**Flood Control Project Maintenance
Levee Inspections**

Fall 2018 Levee Maintenance Deficiency Summary Report

Reclamation District No. 0556 Upper Andrus

Levee Inspection Report By Mile - Fall 2018

Photo 1 of 1 : FA_2018_RD0556_18_24_20180925_00006.jpg

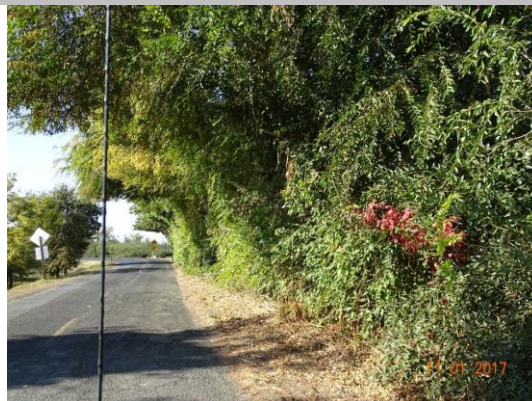
LM Start	0.87	Rating **	U	Issue No.	24
LM End	0.92	Issue Type +	En	Location *	LS
Category	Earthen Levee			GPS Latitude/Longitude	
				Start	End
Item	Vegetation			38.228820 °	38.228480 °
				-121.525853 °	-121.526470 °
DWR ID	DWR_RD0556_01_f_2017_24				
Comment Code					
V6 : Landscaping					
Inspector Comment

Trim/thin landscaping to allow inspection and access to levee slope and toe.

Photo 1 of 1 : FA_2018_RD0556_19_22_20181003_00061.jpg

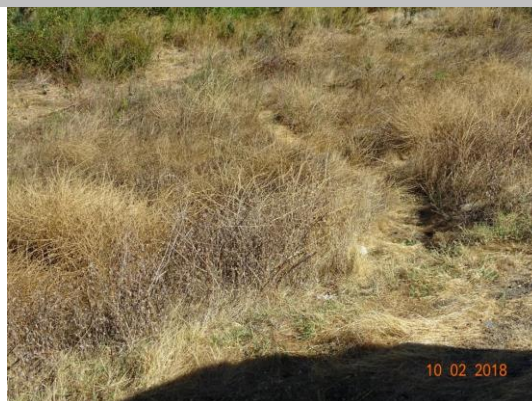
LM Start	0.39	Rating **	A/W	Issue No.	22
LM End	0.39	Issue Type +	Ma	Location *	WS
Category	Earthen Levee			GPS Latitude/Longitude	
				Start	End
Item	Slope Stability			38.238292°	38.238292°
				-121.525362°	-121.525362°
DWR ID	DWR_RD0556_02_f_2018_22				
Comment Code					
S1 : Repair slope instability.					
Inspector Comment					
Foot path digging into levee should be monitored

View of footpath down the water side slope that is beginning to dig into levee (October 2018).

Photo 1 of 1 : FA_2018_RD0556_19_25_20180925_00002.jpg

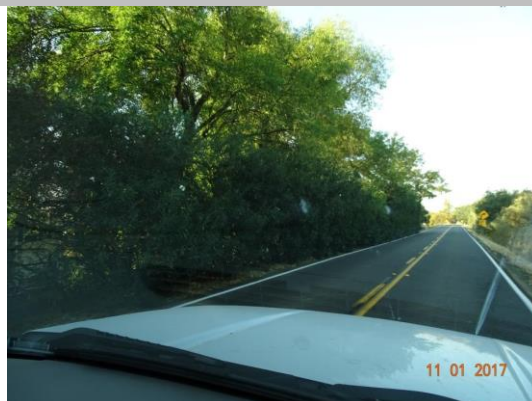
LM Start	0.55	Rating **	M	Issue No.	25
LM End	0.55	Issue Type +	En	Location *	LS
Category	Earthen Levee			GPS Latitude/Longitude	
				Start	End
Item	Vegetation			38.237810°	38.237810°
				-121.528182°	-121.528182°
DWR ID	DWR_RD0556_02_f_2017_25				
Comment Code					
V6 : Landscaping					
Inspector Comment

Trim/thin oleanders.

Photo 1 of 1 : FA_2018_RD0556_19_16_20181023_00078.jpg

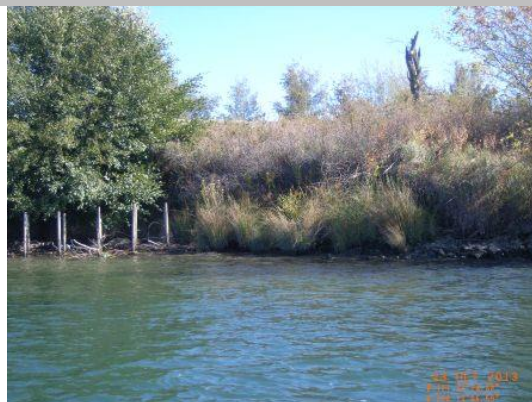
LM Start	3.58	Rating **	M	Issue No.	16
LM End	3.64	Issue Type +	Ma	Location *	WS
Category	Supplemental			GPS Latitude/Longitude	
				Start	End
Item	2017 USACE Erosion Survey, DRAFT			38.218951 °	38.218104 °
				-121.556689 °	-121.556819 °
DWR ID	DWR_RD0556_02_f_2018_16				
Comment Code					
Inspector Comment					
2017 Site ID: SAC 22.7 L					
Status: Eroding					
2017 Field Notes: Minor new erosion at toe.					
Site History: 1997 - Scallops into berm and very close to levee toe.					
2005 - Brush boxes present. 2011 - New toe scour and freshly fallen tree. 2012 - New tree popout has taken significant portion of soil out of the levee.
